**FINAL DRAINAGE REPORT  
FOR  
MONUMENT JUNCTION DEVELOPMENT  
HIGHWAY 105 CORRIDOR &  
JACKSON CREEK PARKWAY  
INTERSECTION IMPROVEMENTS**

July 2023

**CCES  
RESPONSES**

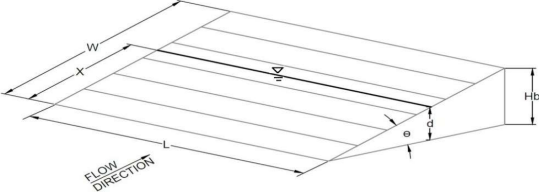
Unresolved:  
 Include calculation for drainage swale along top of retaining wall to show that it is sized to handle the flow.

Pipe ID: **Pipe Run 7**

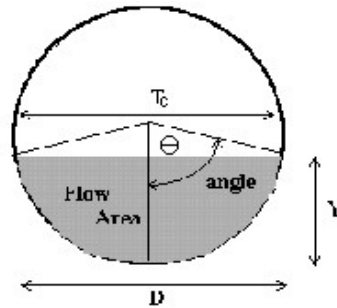
Per ECM section 3.3.1.J.8 maximum storm sewer velocity is 18 fps. Please revise

**REVISED**
